Subject: XPR Torch Heads Change

Effective February 3, 2023, a change to our XPR[®] torches was implemented to improve reliability of the electrical connection between the electrode and the cathode inside the torch head.

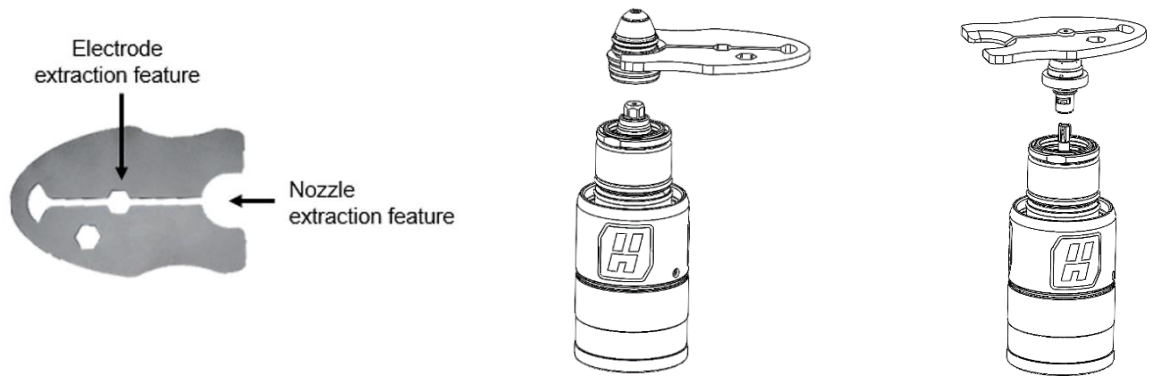
- New XPR torch heads include a differentiated mark “+++ “, making it easier to identify the updated design in the field. See below:
